### **Amendments to the Drawings:**

Type of Response: Amendment Application Number: 10/559,891

### ANNOTATED SHEET SHOWING CHANGES MADE

Figure 4

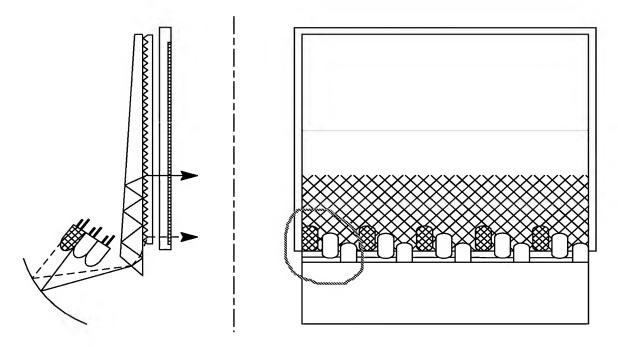
In Figure 4, the top row of LEDs is shown as illuminated in the front view.

The Office Action on page 2 objects to the drawings asserting that Fig. 4 shows the top

row of LEDs illuminated in the side view but the bottom row of LEDs illuminated in the front

view.

In response to this objection, a replacement sheet of drawings illustrating a revised Fig. 4

has been included. The replacement sheet illustrates Fig. 4 showing the top row (instead of the

bottom row) of LEDs illuminated in the front view, which correctly corresponds to the top row

of LEDs illuminated in the side view.
